**Amendments to the Drawings:**

Application No. 10/021,604  
Amdt. Dated September 30, 2005  
Reply to Office Action of August 22, 2005  
Annotated Sheet Showing Changes

**FIG. 1**

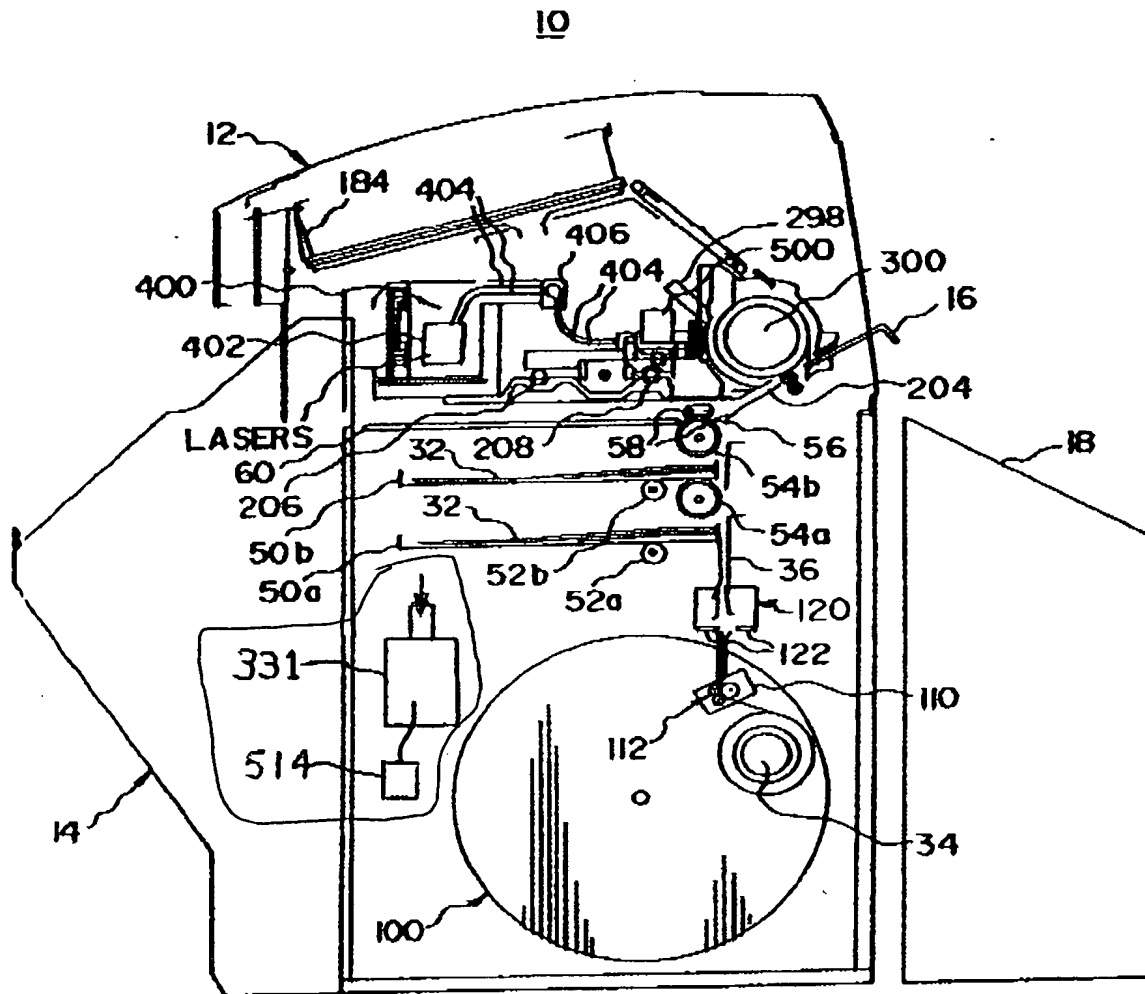
The reference signs, blower 331, vacuum end wall 308, and vacuum supply controller 514 have been added to the drawings.
